## COUNCIL ASSESSMENT REPORT

| Panel Reference                                                             | PPSSNH-212                                                                                                                                                                                          |
| DA Number                                                                   | DA97/21                                                                                                                                                                                             |
| Proposed Development                                                        | Demolition of existing buildings and construction of 26 storey commercial building with part 4, part 5 levels of basement parking                                                                   |

### **2. Safety - Provision of Escape**

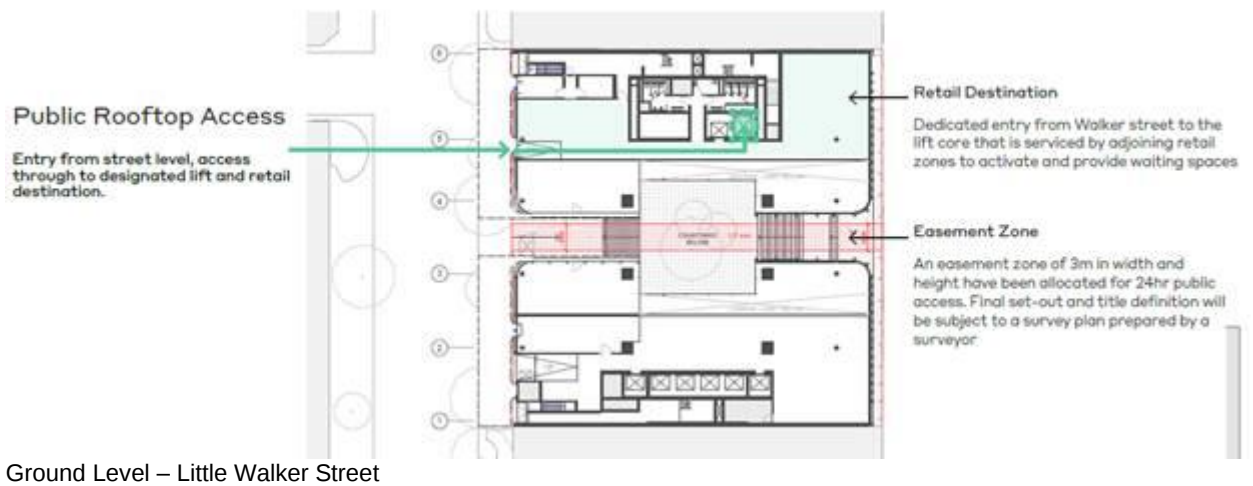
According to the BCA Assessment Report (August 2021), the revised DA lodged in October 2021 has non-compliance in exit travel distances at Basement1, Mezzanine, Ground Floor Little Walker Street, Ground Floor Walker Street, Level 1-26. It is worth noting that the non-compliances occur at all the commercial levels including the rooftop garden. In addition, the BCA Assessment Report (August 2021) also indicated that there are a few levels that have non-compliance in number of the required exits.

According to the submitted BCA Cover Letter, the amended DA has now eliminated a number of previous non-compliances including but not limited to the protection of exposed openings and extended exit travel distances. However, with the absence of the amended BCA Assessment Report, it is not clear on which levels the non-compliances still occur in the amended DA. In our assessment, the non-compliances in exit travel distances may still exist, especially at the podium levels and the podium top garden.

Planning Comment – A suitable condition will be applied in relation to improving access to the rooftop garden. The proposal is considered satisfactory with regard to the BCA, subject to conditions of consent.

**Figure B-2.1:**

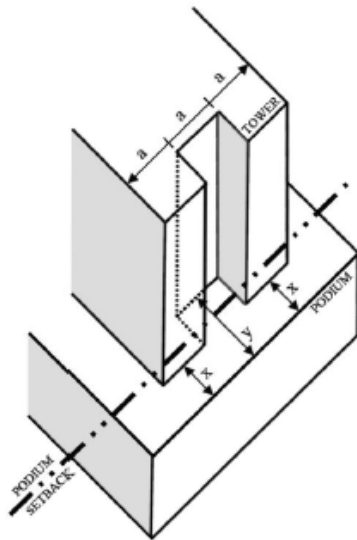
The amended application states that the tower has compliant weighted average setbacks to Walker Street and Little Walker Street, based on the formula  $1 + 9 / 2 = 5\text{m}$ . The formula expressed in NSDCP 2013 depicts the frontage dimension (ie, width) "a" as identical in the projections and recesses, which provides for a formula of  $x + x + y / 3$ .

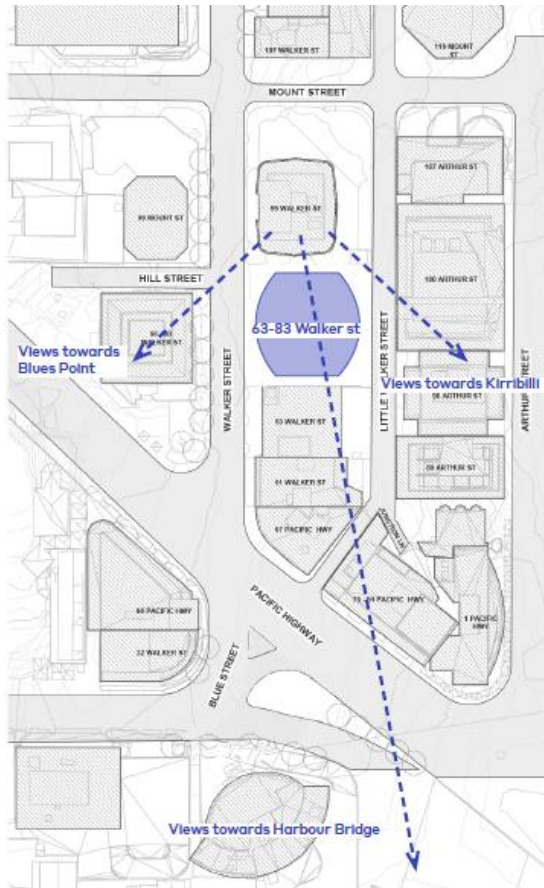
Assessment – The complying part of the development (ie, that part up to RL 145) obscures views, including iconic views, from No.99 Walker Street.

Future views resulting from a potential future redevelopment of No.99 Walker Street are beyond the considerations in *Tenacity*.

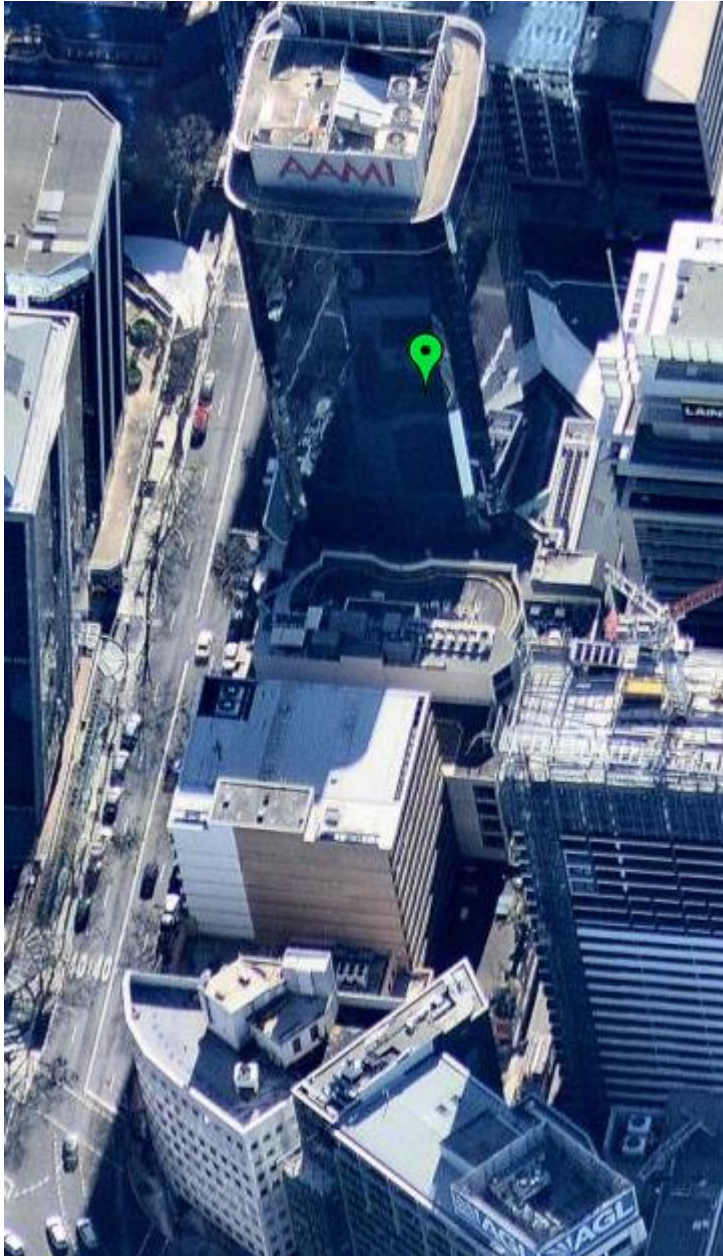
Assessment – The extent of view impact if referring to residential development would be described as devastating, as the proposal almost entirely obscures existing views to the south:
